VARIANCE APPLICATION SUMMARY

File Number	V-24-33
Property Address	817 N HAMILTON RD GAHANNA, OH 43230
Parcel ID	025-001918
Zoning District	RI - Restricted Institutional
Project/Business Name	One Church Tenant Improvement
Applicant	Tony Torres ttorres@visioneeringstudios.com 714-780-2873
Description of Variance Request	Various variance requests due to required landscape islands, EV chargers, use of temporary gravel lot, and exterior building materials.

STATEMENT OF VARIANCE FOR
'ONE CHURCH' AUDITORIUM VARIANCE (V-24-33)

PLANNING COMMISSION STAFF REPORT

6' PRIVACY FENCE

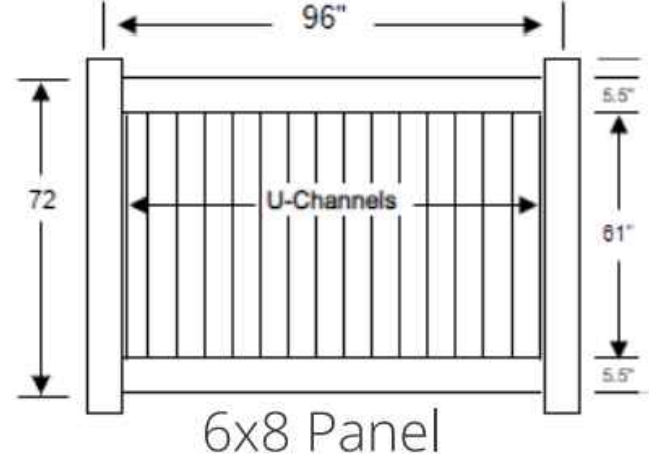
The new site design proposes to use existing trees along shared boundaries to meet Buffer A requirements, with no new tree planting due to the addition of a continuous 6-foot high fence. This continuous fence exceeds the 80% screening requirement during all seasons.

Although the applicant proposes not planting any new trees to meet buffer and screening requirements, there are some existing mature trees that will remain along the property line. Additionally, a 6 ft high privacy fence will help screen the negative effects of a parking lot.

CERTIFICATE OF APPROPRIATENESS
SITE IMPROVEMENTS PLAN
FOR:
One Church
GAHANNA, OHIO

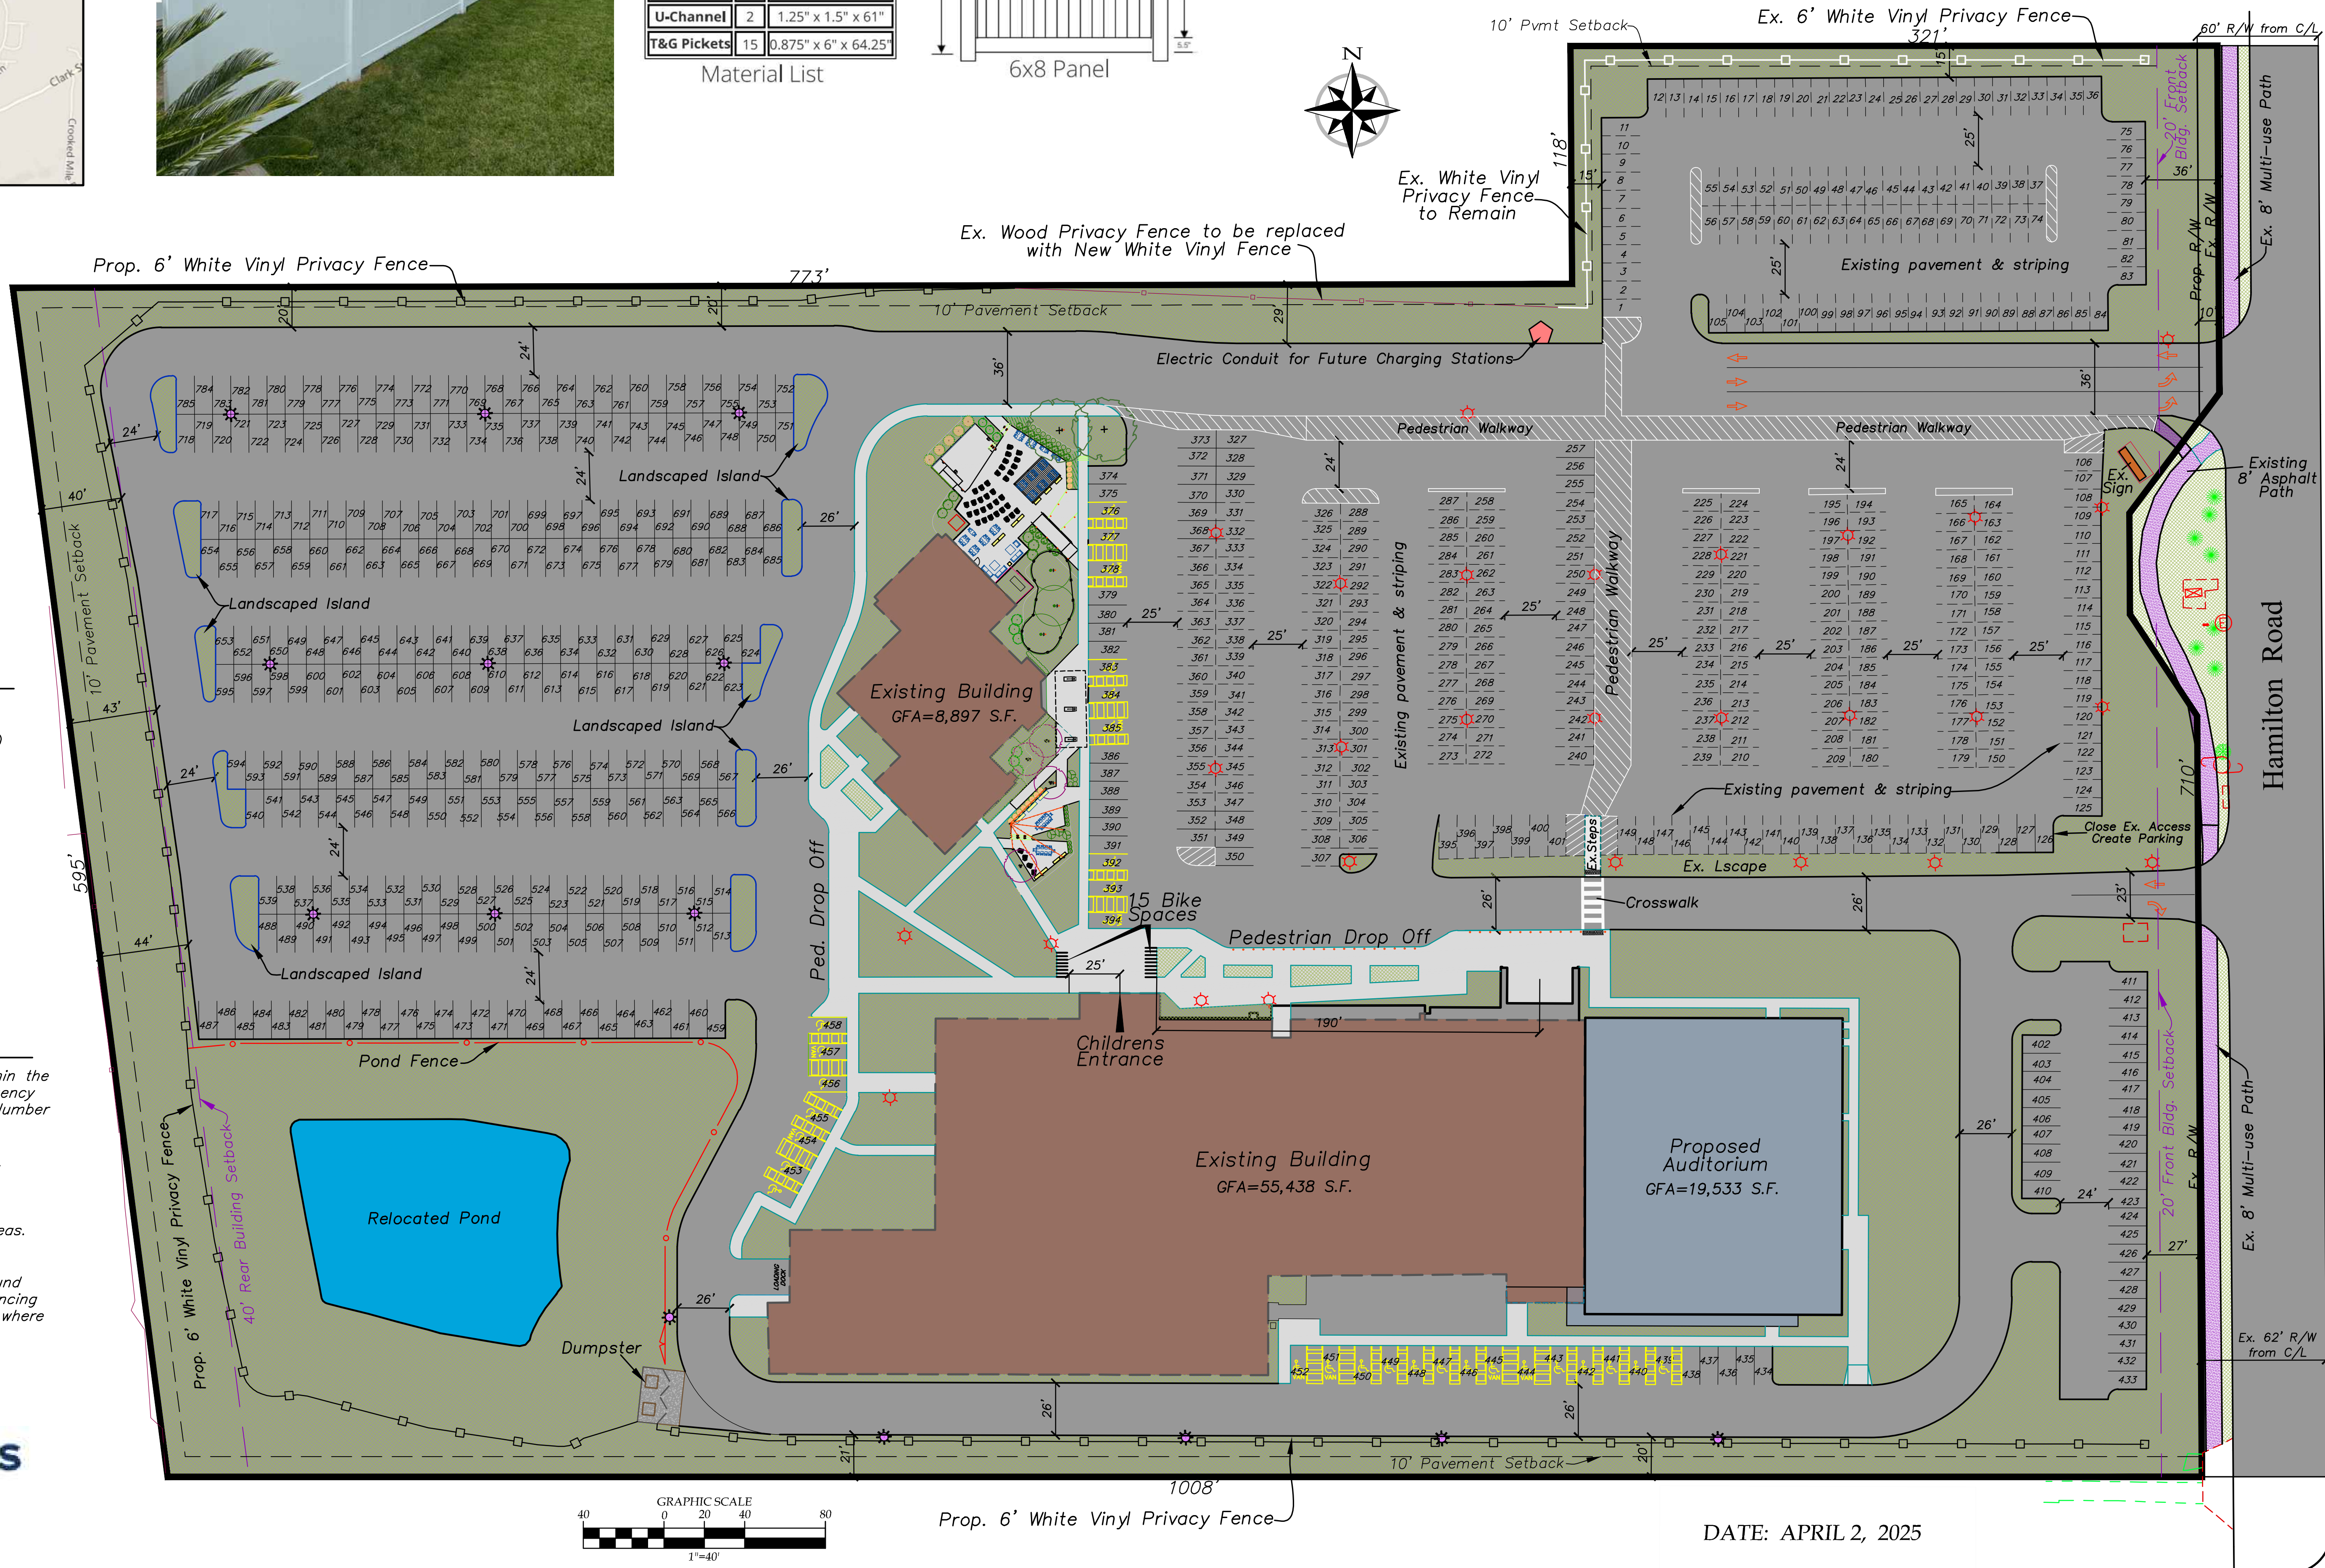
Currently, there are existing parking lots that extend beyond the front-facing exterior wall of the expanded Worship Building. We have relocated the new east parking lot to align with the existing parking lots. This parking lot is proposed in order to maximize the parking needed during church services and the changeover between services.

The primary use of the site is for limited timeframe worship sessions or meetings of 1-hour durations, which is not conducive to effective vehicle charging. The Owner requests to install an electrical power pull location for future EV charging stations at a central location should usage change for the site. Refer to revised site plan for reference.

Staff recommends approval of all three variance requests. Although there will be one new parking area to the front of the existing church building, it will line up exactly with the existing parking lot to the north and will be screened from the ROW with a three ft high continuous hedge and 16 3 cal in trees.

Finally, the applicant is not proposing any EV charging stations since vehicles are typically parked for around one hour, except for employees. The applicant proposes installing an electrical power pull location for future EV charging stations if deemed necessary in the future.
